HISTORIC PRESERVATION COMMISSION

Monday, March 2nd, 2026

**City of Avondale Estates
Historic Preservation Commission
COA Application Review***

City of Avondale Estates
Historic Preservation Commission
COA Application Review*

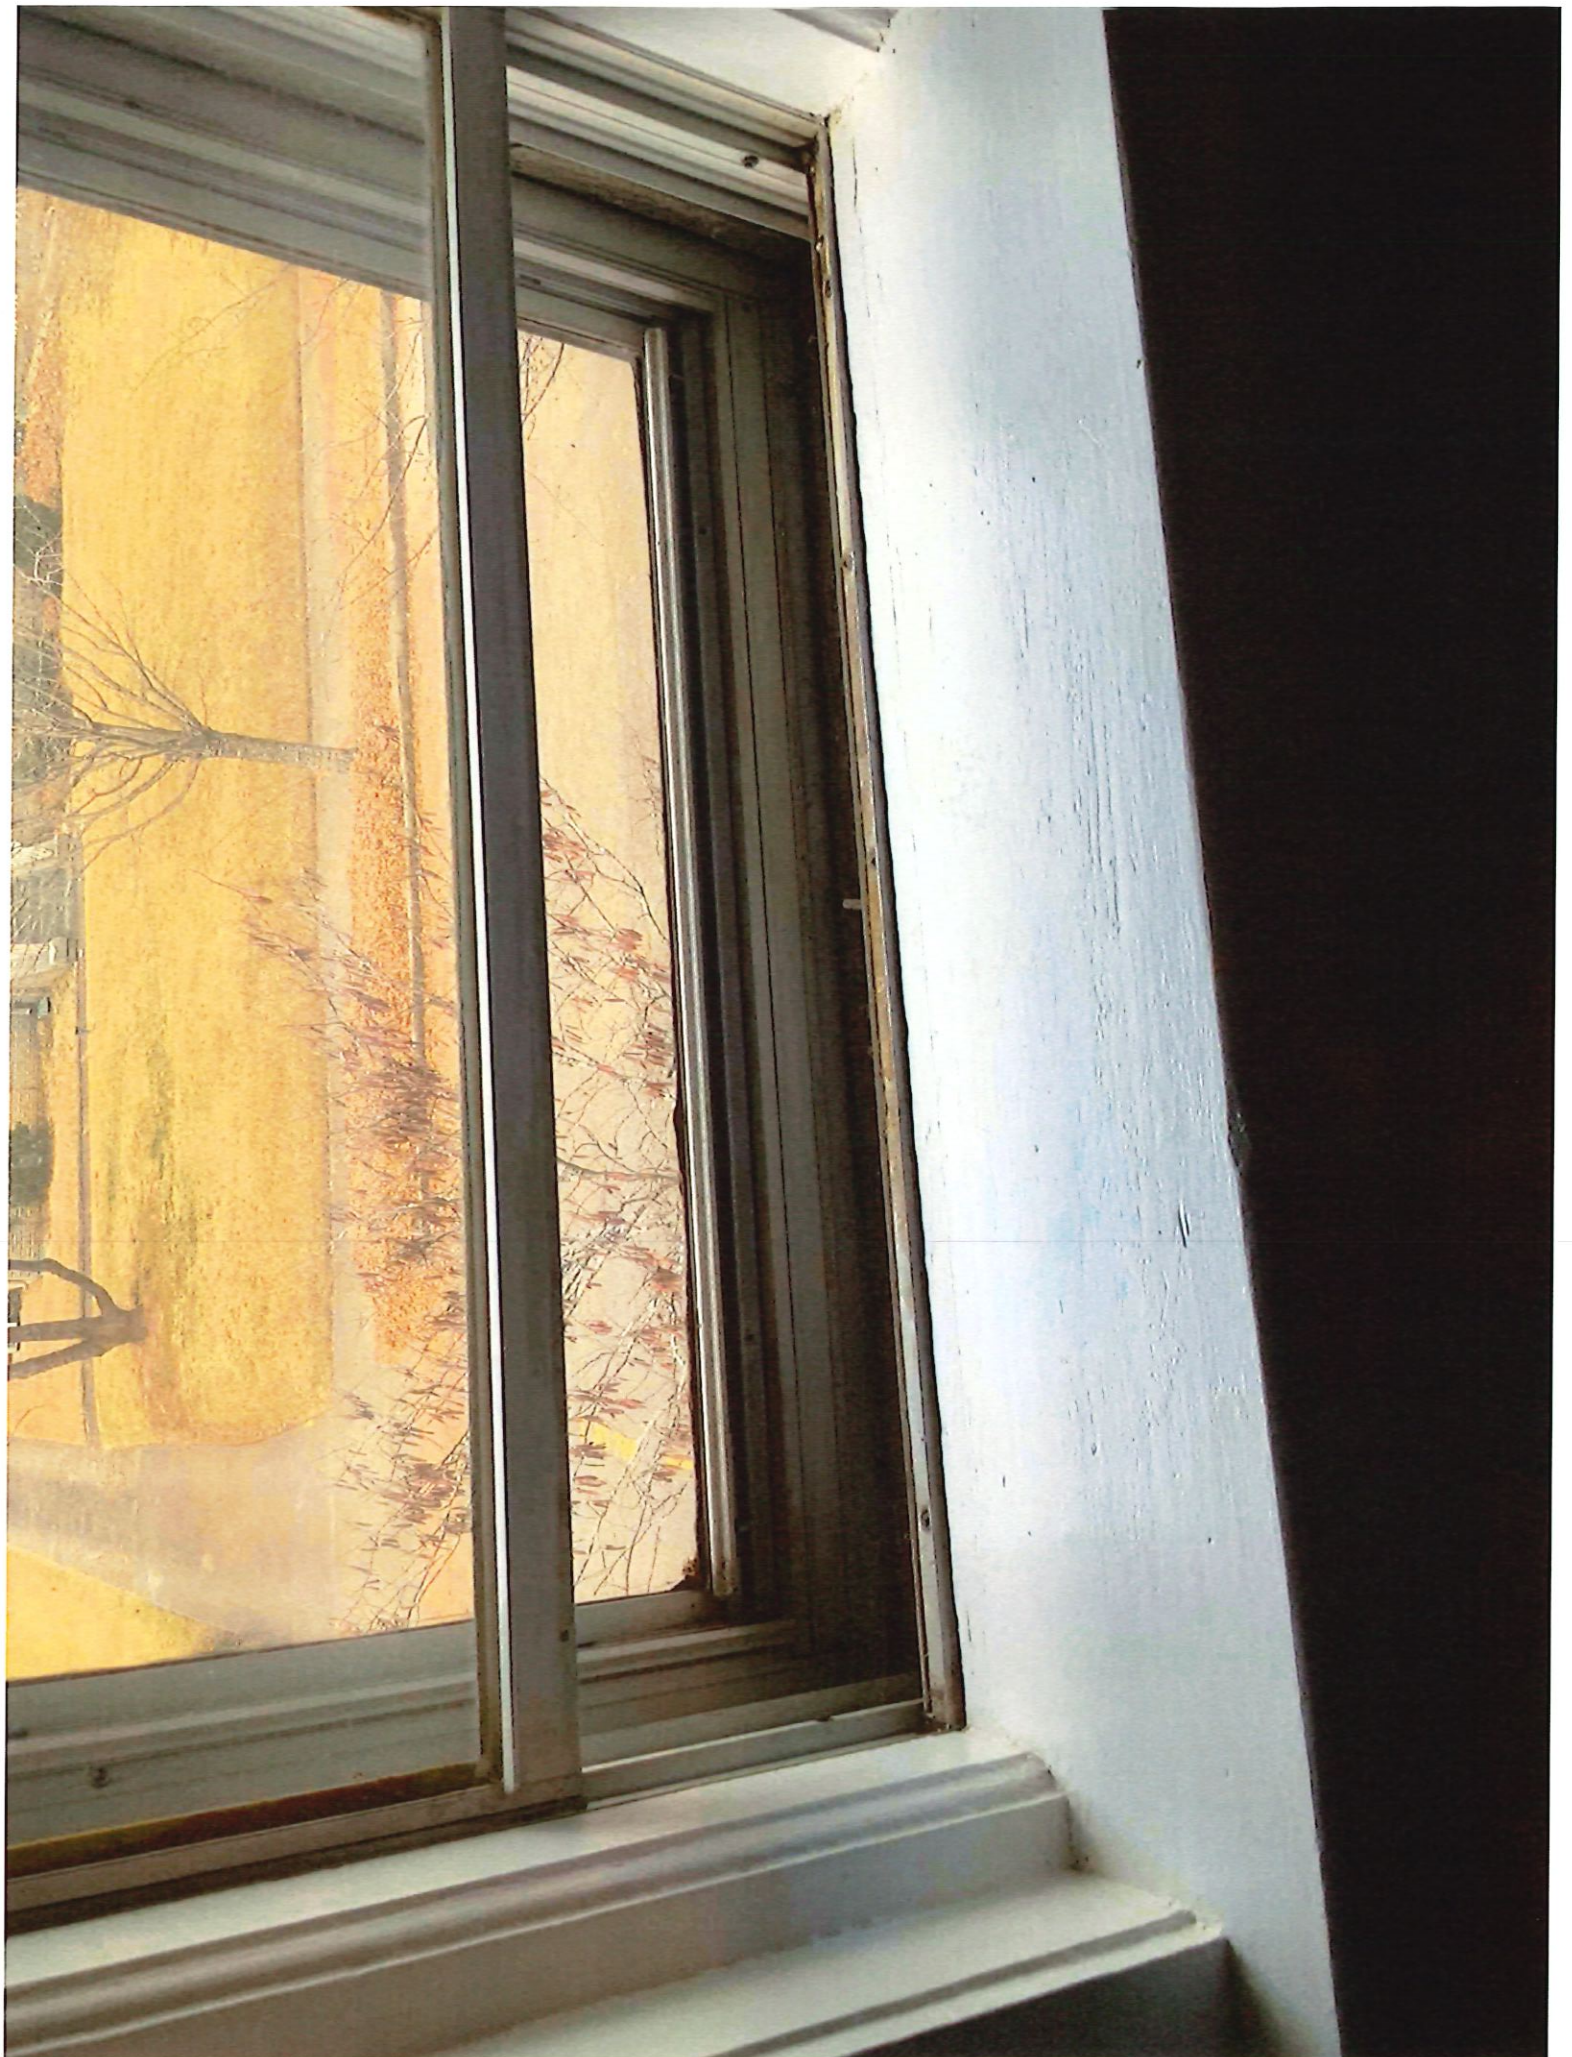
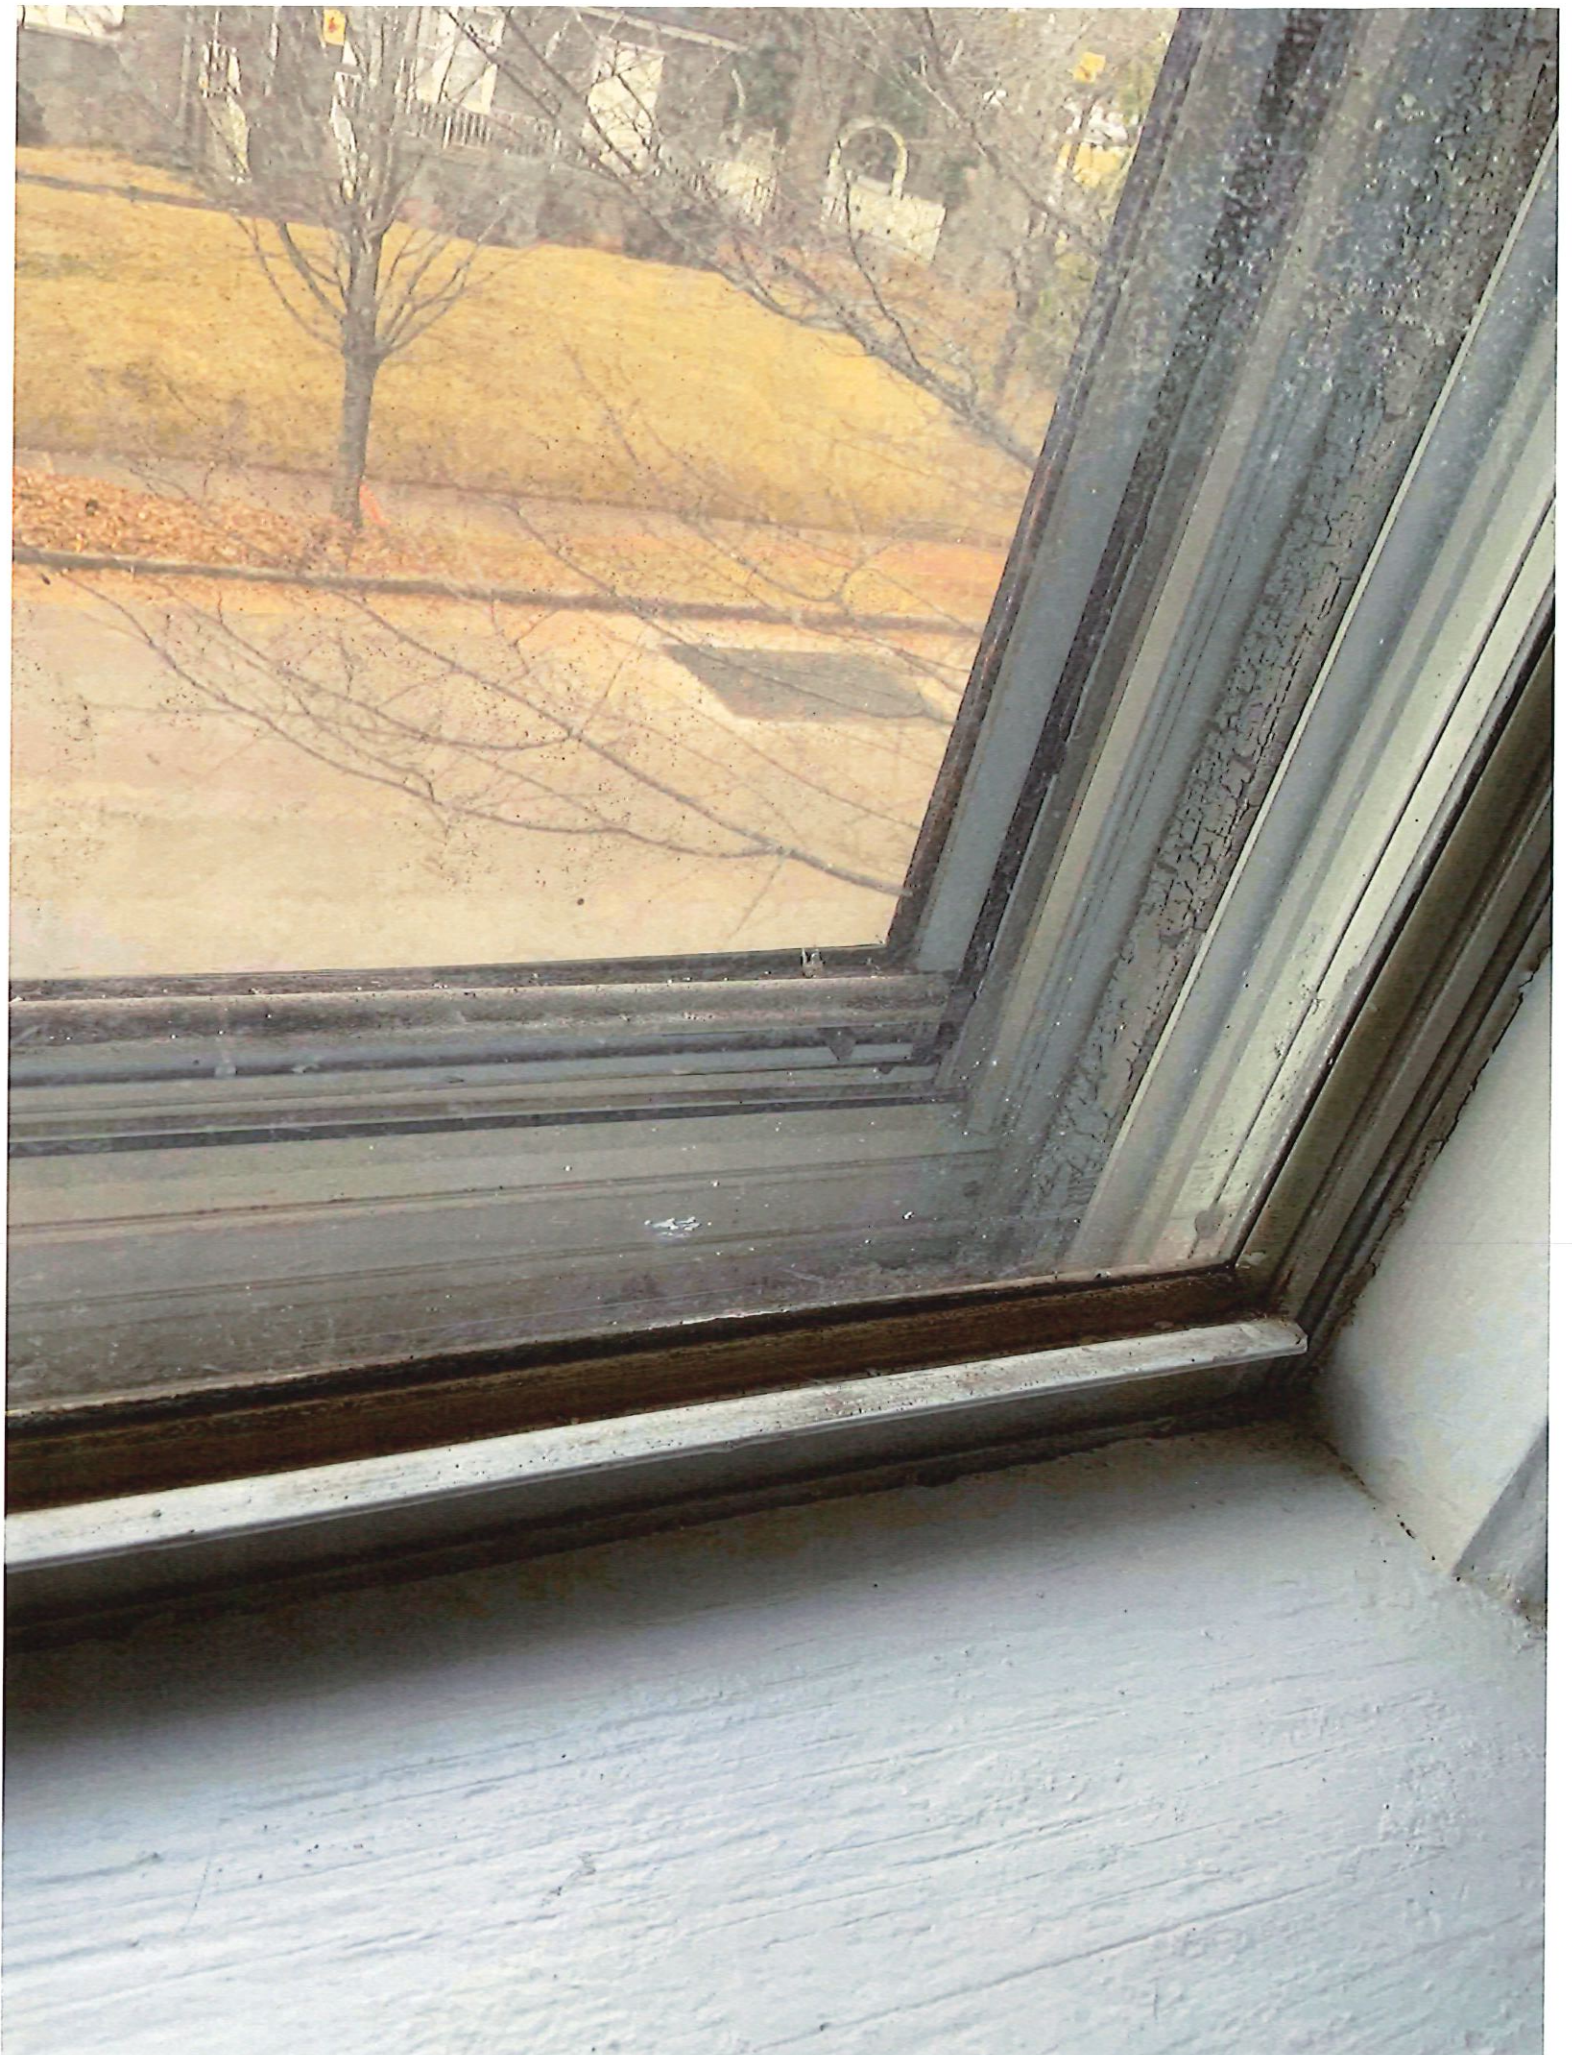
Analysis: The project proposes to replace five of the house's windows on the side and rear elevations. The five windows have been previously replaced and are not original to the house. These windows are 1-over-1, double-hung and appear to be a combination of metal, vinyl, and wood windows with storm windows. The proposed replacement windows will be wood with exterior cladding, 6-over-1, double-hung windows to match the appearance of the existing historic wood windows in the remainder of the house.

The windows proposed to be replaced are nonhistoric replacement windows. Therefore, the guidelines allow for them to be replaced. The proposed 6-over-1, double-hung windows may be TDLs or SDLs, and the rails, stiles, and muntin widths should match those of the house's existing historic 6-over-1 windows. The new windows' material should be wood without exterior cladding since synthetic materials are not allowed on original portions of Preservation Designation properties (see *Guidelines for Materials* below).

The *Historic District Guidelines for Materials on Preservation Designation* properties state that no new synthetic materials may be used on the original portions of Preservation Designation properties. Repair all components with the same materials. The proposed replacement windows should be wood without exterior cladding.

- Replacement windows should be wood without exterior cladding.
- Rails, stiles, and muntin widths should match those of the house's existing historic 6-over-1 windows.

Design photos for proposed windows (exact same specs as windows replaced elsewhere in house)

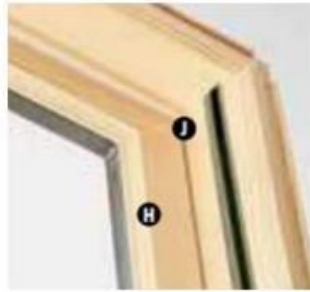
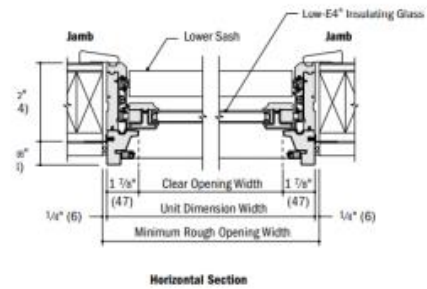
The porch's 4-over-4, double-hung wood windows are not original but may be considered historic elements. Replacement windows should be wood as proposed. The use of 4-over-4 sash instead of 6-over-1 should be considered to help maintain the porch's historic appearance.

- New enclosure materials on the porch should be wood rather than a synthetic material such as fiber-cement.
- Respect the porch's existing historic elements by using panels with a similar appearance to the beaded board panels and by considering the use of 4-over-4, double-hung, wood windows rather than 6-over-1.
- New rear entrance and basement doors should be wood rather than a synthetic material such as fiberglass.

PROPOSED
SITE PLAN

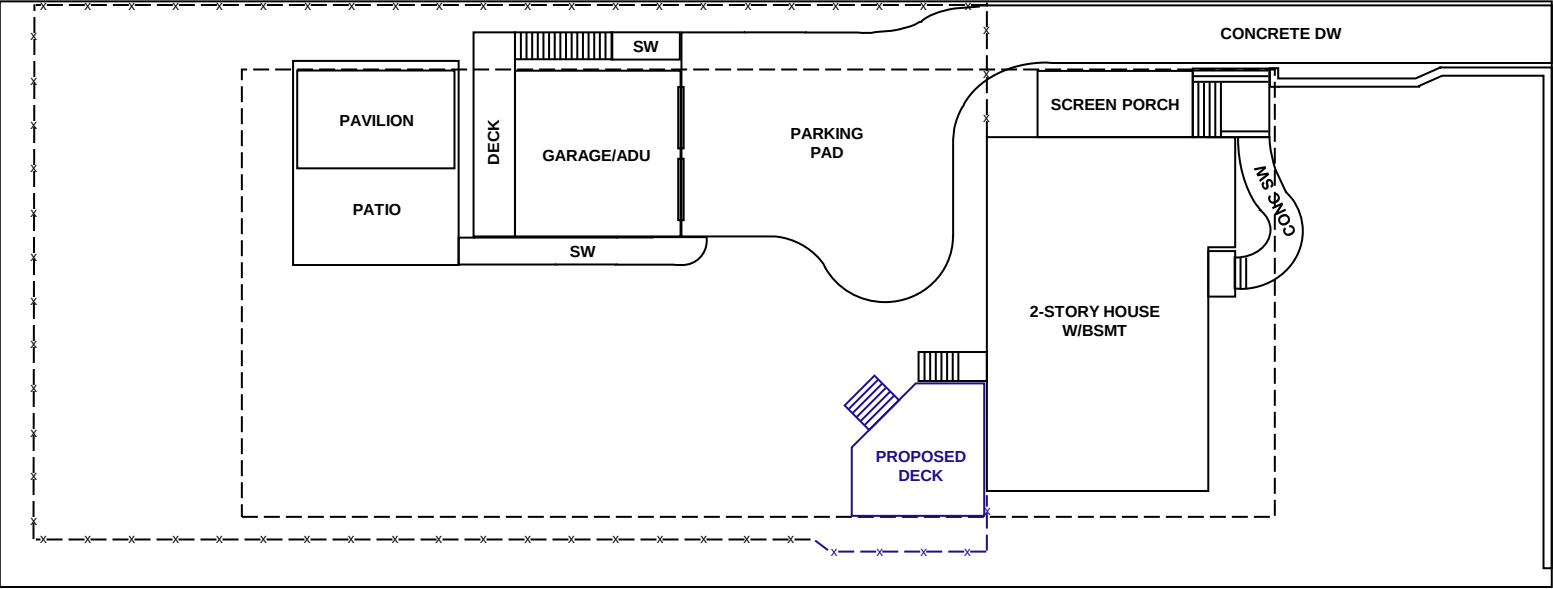
The addition of a new deck is allowed on the house's rear elevation (see *Guidelines for Materials* below). Removal of the masonry steps is also allowed due to their location at the rear elevation. The additional 400 SF of the new deck minus the rear steps and concrete landing brings the total lot coverage to 34.6%.
